Project	IEEE 802.16 Broadband Wireless Access Working Group < http://ieee802.org/16 >	
Title	Clarification of CQICH allocation request header	
Date Submitted	2005-04-27	
Source(s)	Yongseok Jin, Bin-Chul Ihm, Jin Young Chun, and Ki-seon Ryu LG Electronics. Inc.	Voice: 82-31-450-7187 Fax: 82-31-450-7129 jayjay@lge.com
Re:	This is a contribution to IEEE 802.16e.	
Abstract	In the case that MS requests CQICH bandwidth to report the data that are much longer than 4 or 6bit, this becomes impossible because data must be transmitted over a CQI channel which is based on 4 or 6 bits.	
Purpose	We suggest to add a new table which consists of the feedback contents only transmitted over CQICH for feedback type of this header	
Notice	This document has been prepared to assist IEEE 802.16. It is offered as a basis for discussion and is not binding on the contributing individual(s) or organization(s). The material in this document is subject to change in form and content after further study. The contributor(s) reserve(s) the right to add, amend or withdraw material contained herein.

Clarification of CQICH allocation header

Figure 20d—CQICH Allocation request header

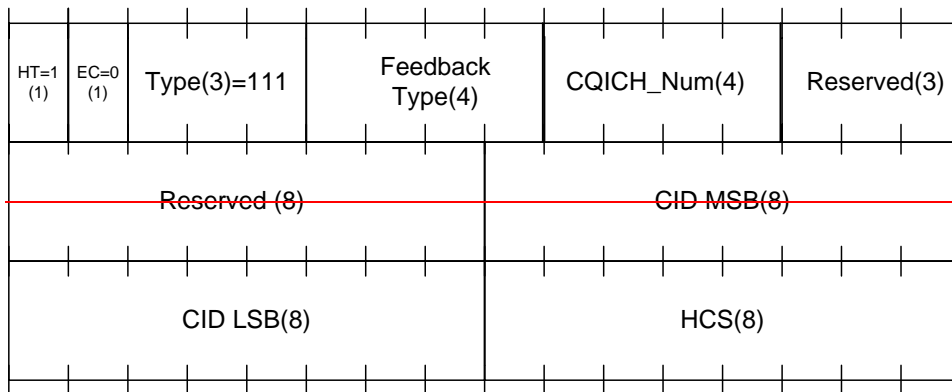
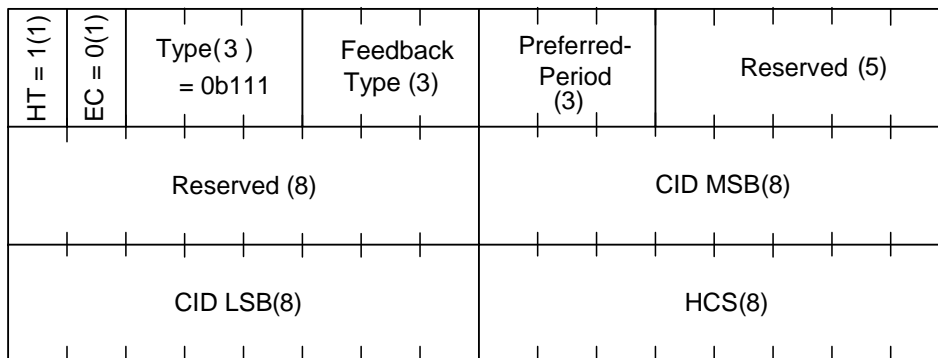
To solve the problem above, we suggest to add a new table-7x which consists of the feedback contents transmitted over CQICH. Moreover, the new table includes that 'Anchor BS report' field for Fast Anchor BS selection Feedback mechanism In addition, in order that MS requests BS to allocate Fast-feedback channel with period which MS prefer, we add 'Preferred-Period'.

[To clarity, add new table and new field in the section 6.3.2.1.2.3]

The CQICH Allocation request PDU shall consist of CQICH Allocation request header alone and shall not contain a payload. The CQICH Allocation request header is illustrated in Figure 20d

- a) The length of the header shall always be 6 bytes.
- b) The EC field shall be set to 0, indicating no encryption.
- c) The CID shall indicate the MS basic CID.
- d) The Type field shall be 0b111.

Name	Length(bits)	Description
HT	1	Header Type =1
EC	1	Always set to zero
Type	3	Set according to Table 7i Type = 0b111
Feedback type	3	Set according to Table 7x
CQICH_Num	4	The number of CQICH requested by MS
Preferred-Period(=p)	3	CQICH allocation period MS prefer. The value is defined by 2^p frame.
RSVD	12-13	Set to zero
CID	16	MS basic CID
HCS	8	Header Check Sequence (same usage as HCS entry in Table 5)
